REGIONAL REVIEW NOTIFICATION

ARC REVIEW CODE: R1712181

Name of Proposal: Emerson Center (DRI 2764)

EMERSON CENTER DRI
City of Smyrna
Natural Resources Group Review Comments
December 13, 2017

DRI SITE PLAN

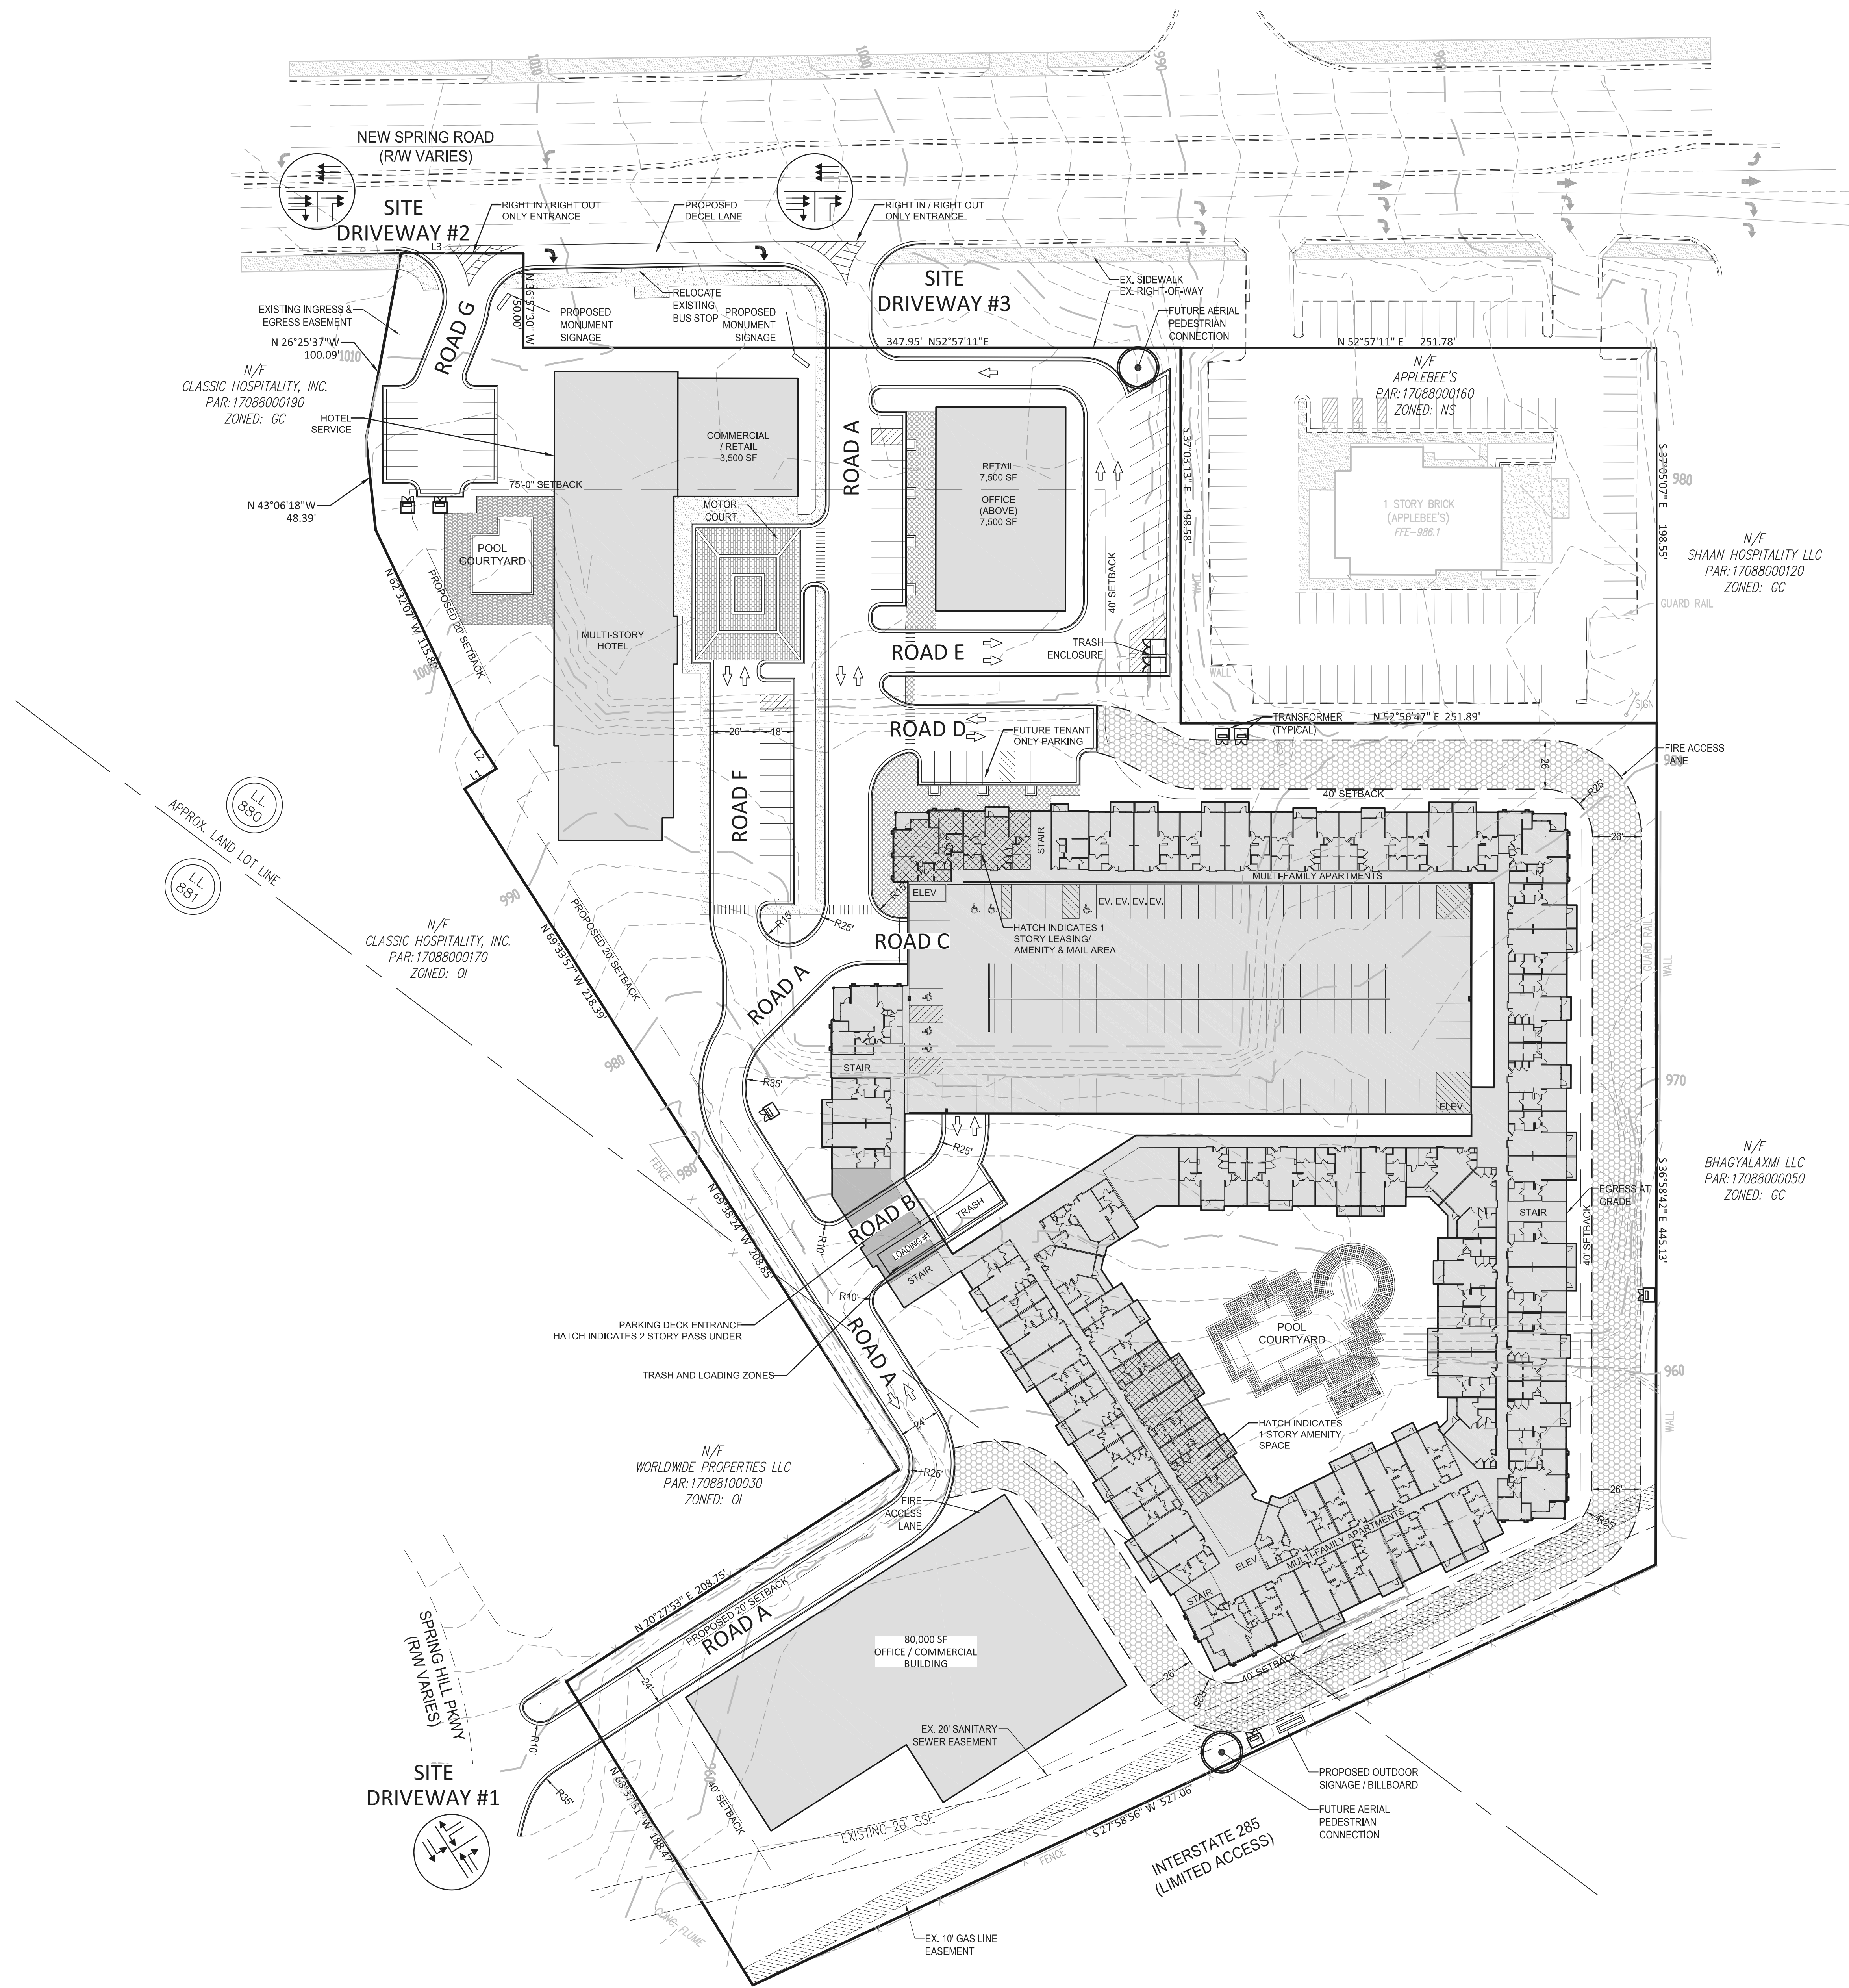
Pedestrian facilities are currently available along existing roadways allowing for safe accessibility. The site plan does not provide information regarding pedestrian and bicycle facilities.

The site plan does not provide specific information or depictions of bicycle and pedestrian facilities. While there are opportunities vis site design to provide connectivity to adjacent parcels, the site plan does not show any proposed connections.
